**Identification cards — Contactless
integrated circuit cards — Proximity
cards —**

**Part 2:
Radio frequency power and signal
interface**

**AMENDMENT 1: Limits of electromagnetic
disturbance levels parasitically generated by
the PICC**

Amendment 1 to ISO/IEC 14443-2:2010 was prepared by Joint Technical Committee ISO/IEC JTC 1, *Information technology*, Subcommittee SC 17, *Cards and personal identification*.

Figure 18 — Illustration of allowed EMD spikes

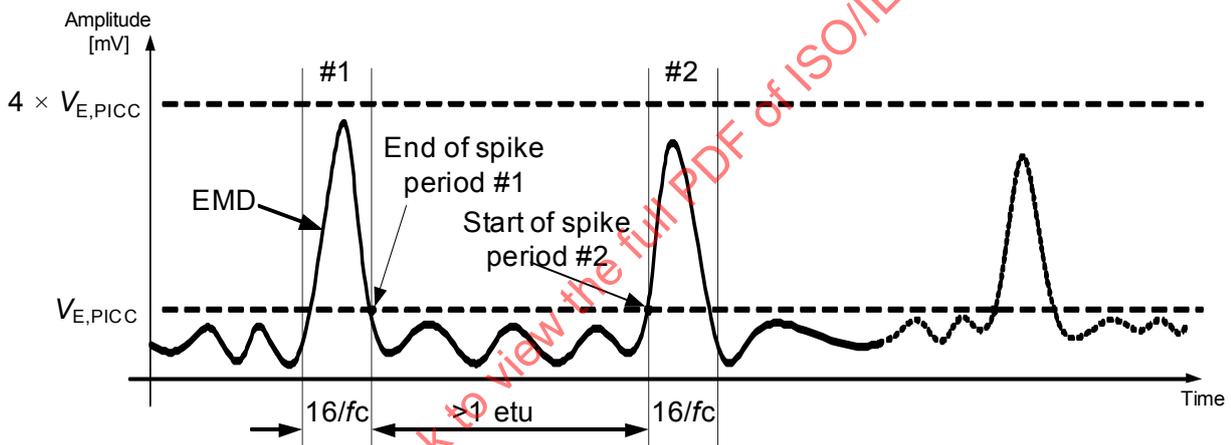
During this low EMD time, the EMD level may exceed $V_{E,PICC}$ for no more than two short periods of $16/fc$ if:

- it never exceeds $4 \times V_{E,PICC}$ and
- in case of two periods, the time between the two periods is greater than 1 etu.

Figure 18 shows an illustration of such allowed EMD spikes.
